2947 EASTLAKE

2947 Eastlake Ave E, Seattle WA

8.0 EDG SUMMARY

8.0 ITEMIZED RESPONSE TO EDG

4C

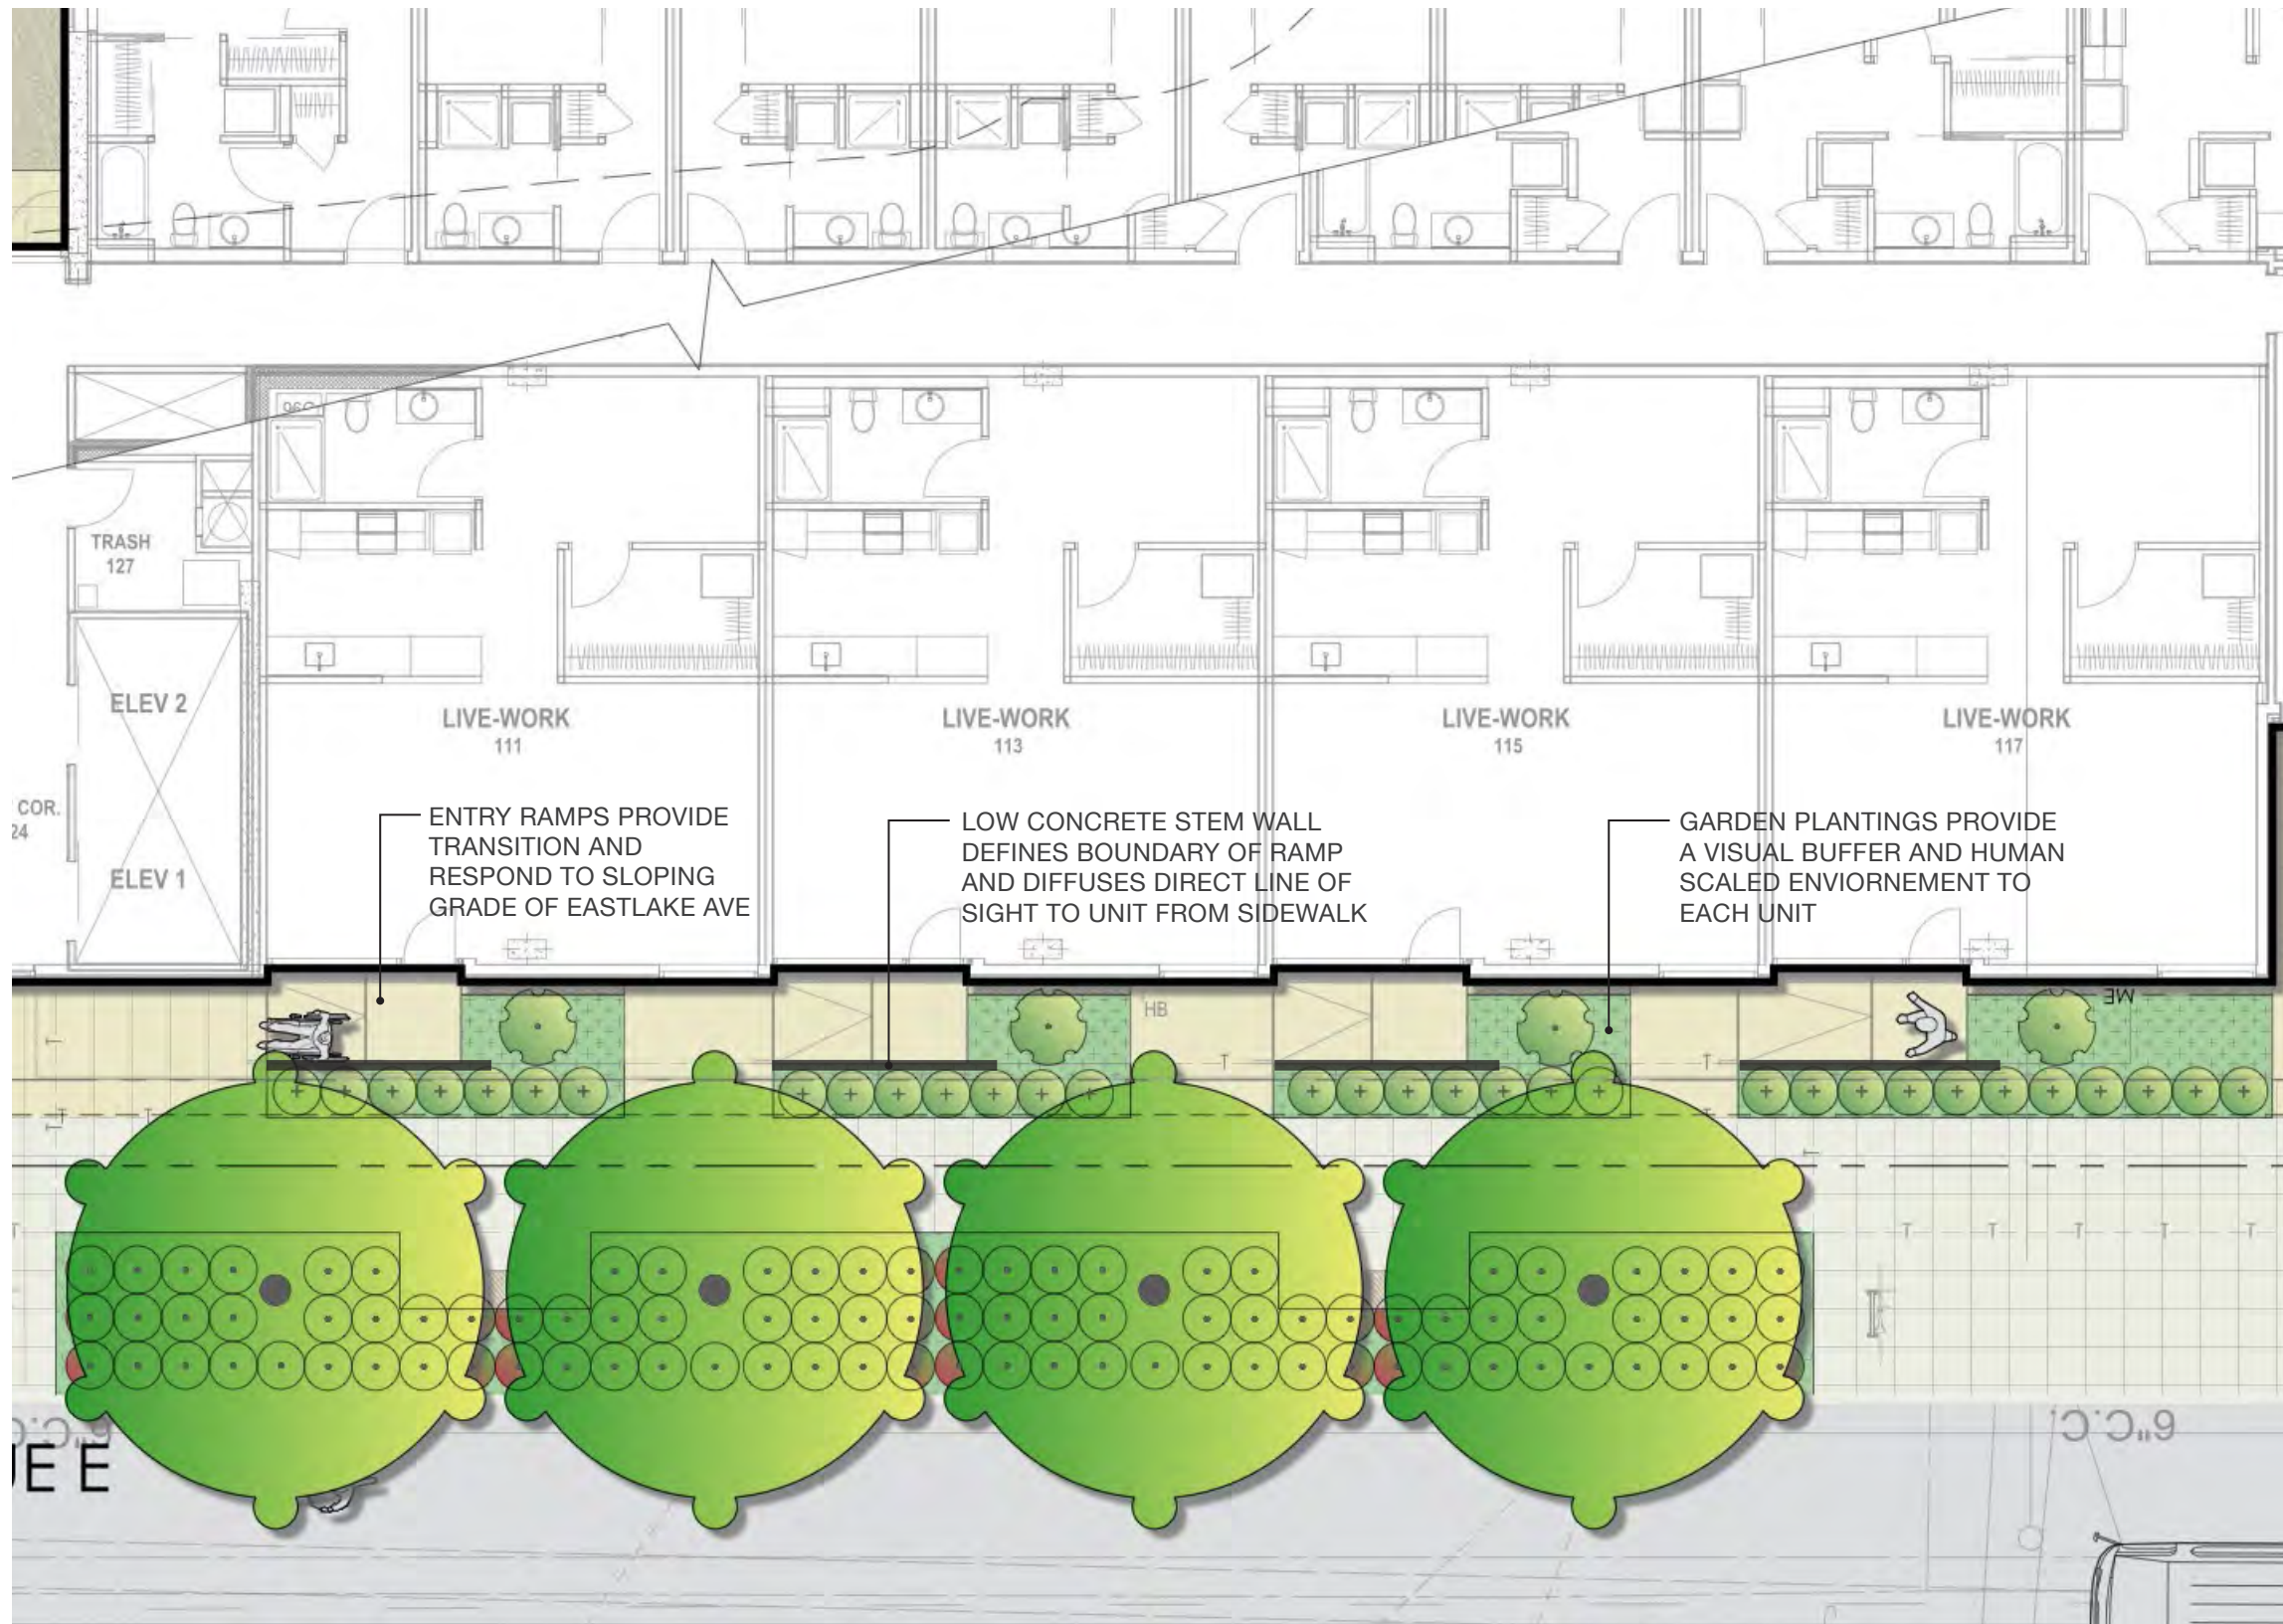
e) The Board noted that the step in the southern volume associated with the Shoreline setback line should be carefully articulated to result in a unified and coherent design. (DC2, DC2-B)

The design team chose to make the step in the southern volume vertically continuous on all residential levels, highlighted by the dashed area on the adjacent image. This move clarifies the massing expression and simplifies exterior detailing. This expression also acts harmoniously with the stepped massing of the northern volume.

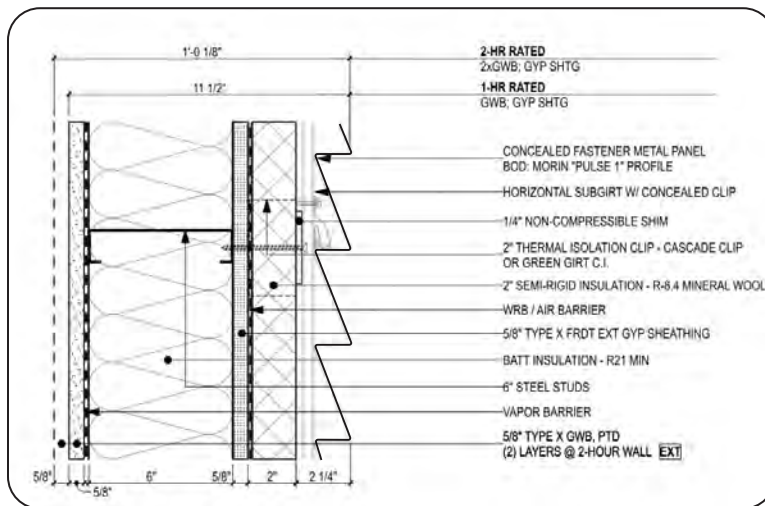
5b b) The Board encouraged further development of landscaped areas at the Live/Work units on Eastlake to help create a buffer that strikes an appropriate balance between privacy and security and engagement with the public realm. (PL3-B, PL3-A)

The exterior entrances of each Live/Work unit integrate a ramped surface, low concrete stem wall and a planted garden space. This zone acts as a *stoop* or *front porch* on the avenue and provides a human-scaled transition between the public realm of the sidewalk and private interior spaces of the units.

EAST ELEVATION

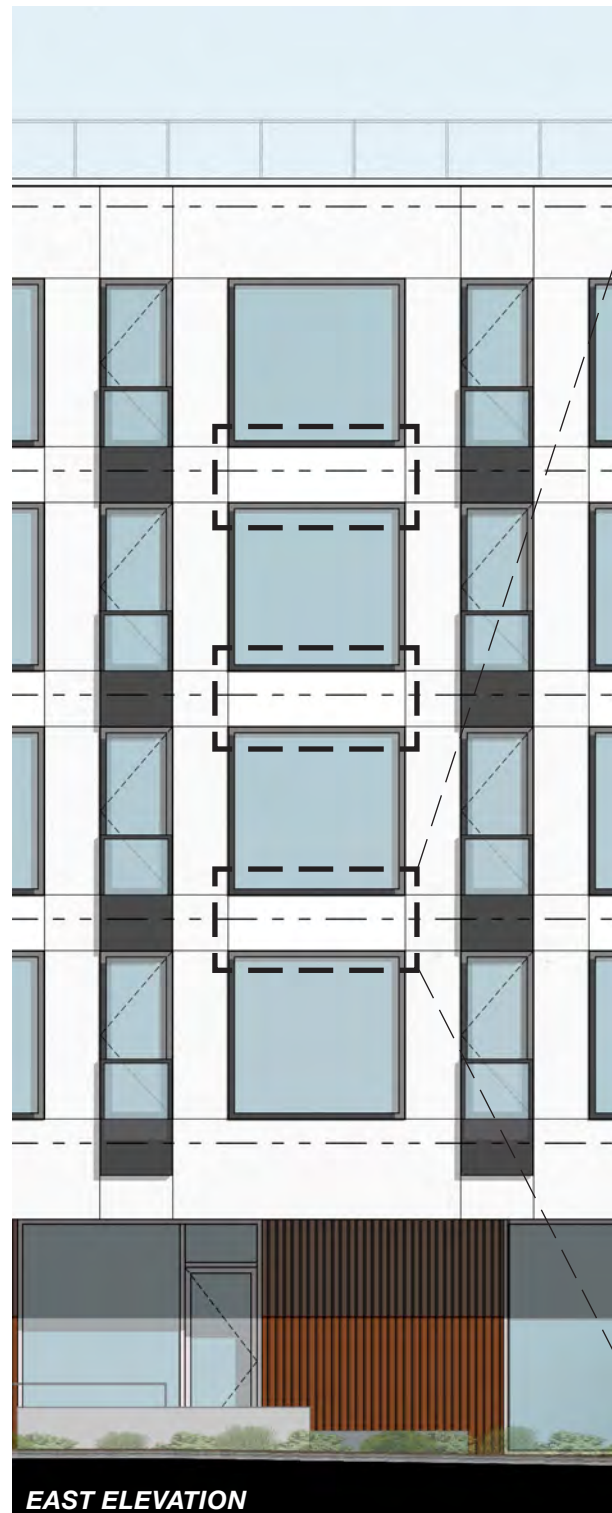
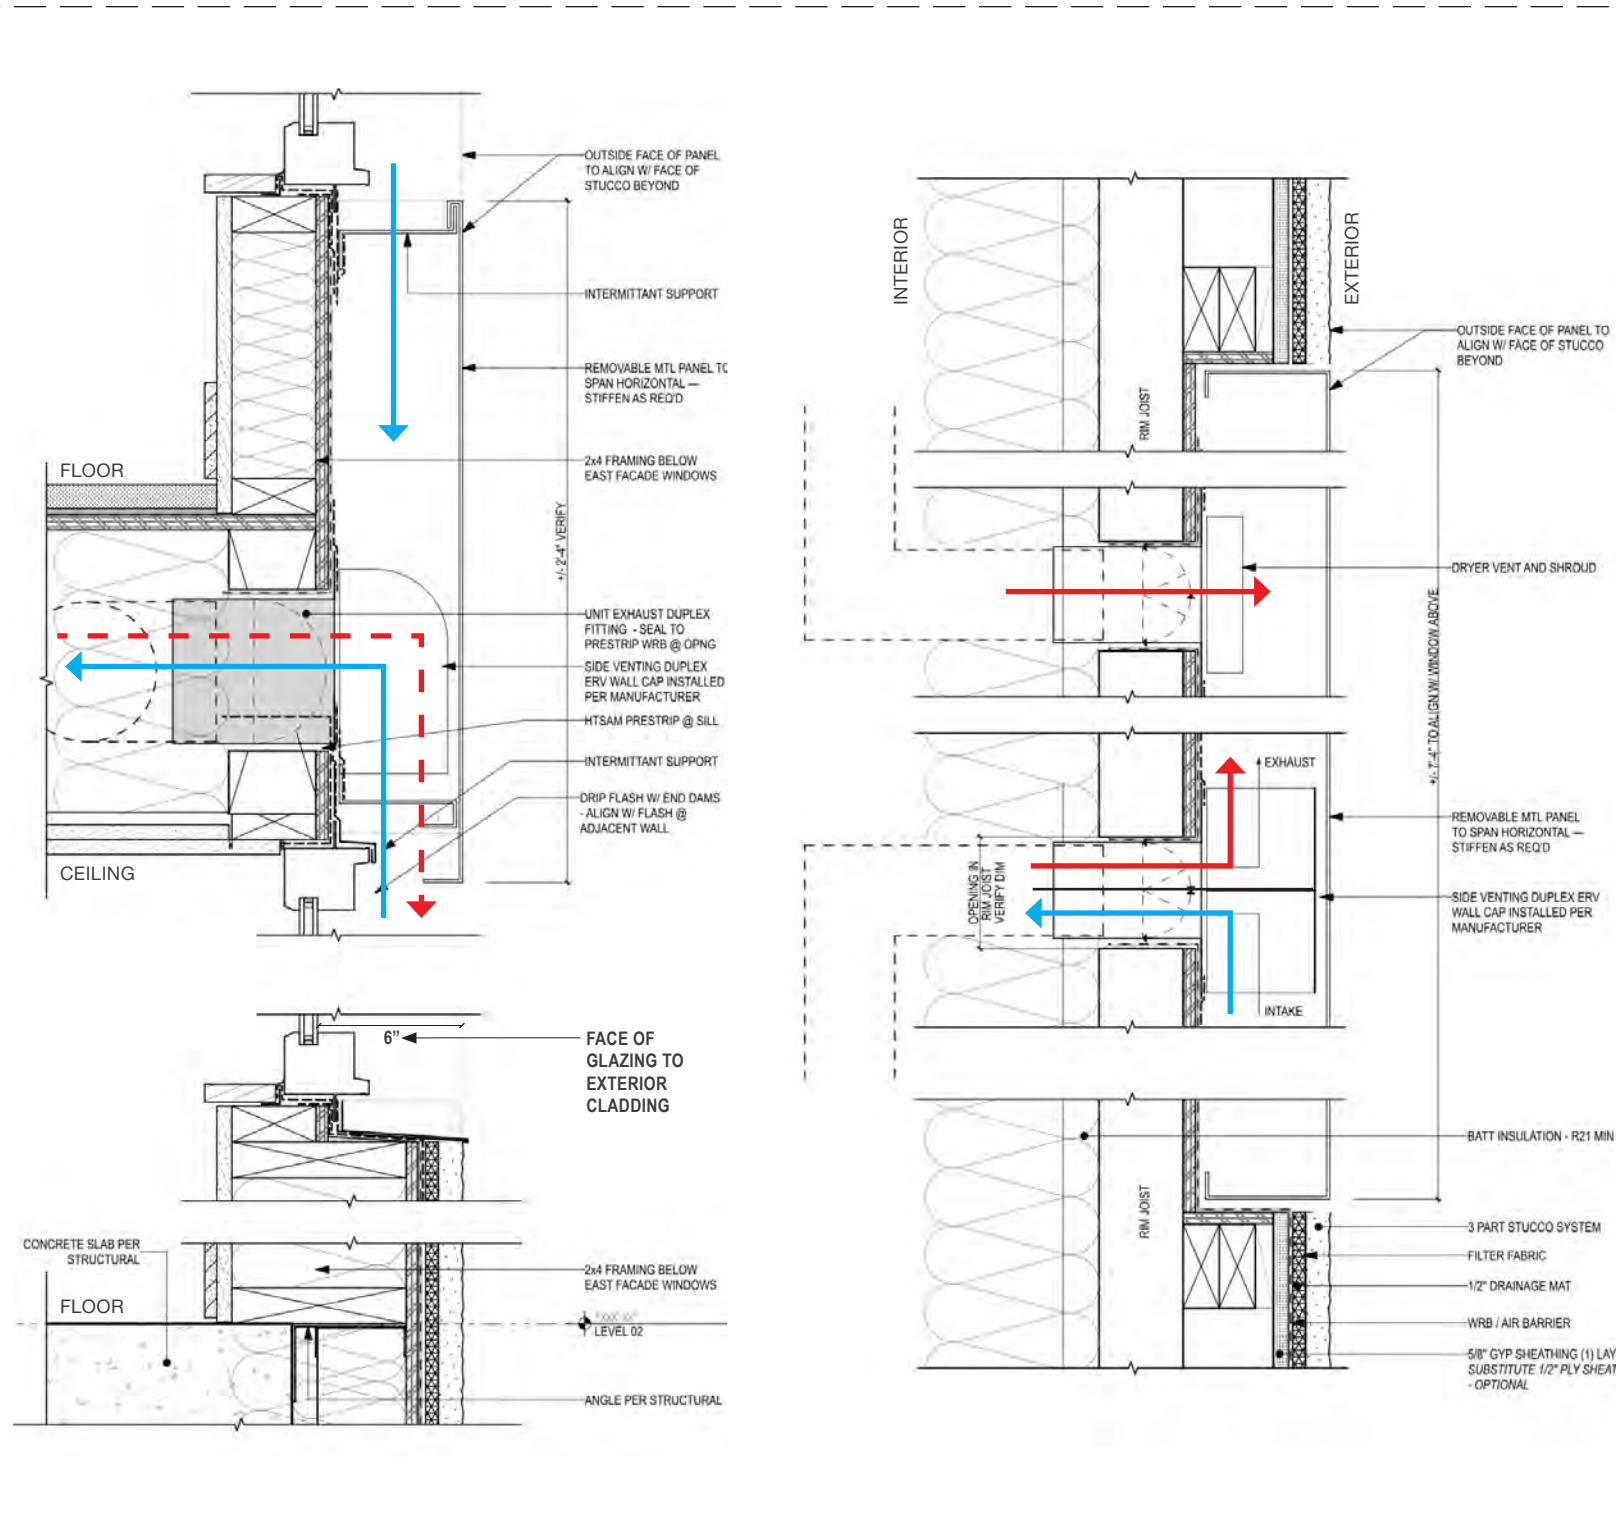
6a a) The Board agreed that the exterior materials and detailing will be critical elements in creating the depth, shadow, texture, and visual interest required to mitigate height bulk and scale, particularly the great length and flatness of the upper levels of the Eastlake Ave E facade. (DC2-A, CS2-D, DC2-C, DC2-B, DC2-D)

A variety of design strategies are employed to create visual interest and depth to the facade. The overall design concept creates a simple three-part massing of floating stucco boxes. These elements create an undercut at the street level for pedestrian scale. Vertical metal panel cladding contrasts the stucco to provide warmth and interest with additional color and shadow. The window glazing on levels 2-5 along Eastlake Ave and E Allison St is inset by 6" with black brake metal frames. This provides depth and shadow while complimenting the primarily white stucco facade. Carefully composed joint lines compliment the window pattern. Each apartment incorporates a juliet balcony and operable exterior door. These glass balconies with integrated black metal panels add texture and allow inhabitants to animate the facade.
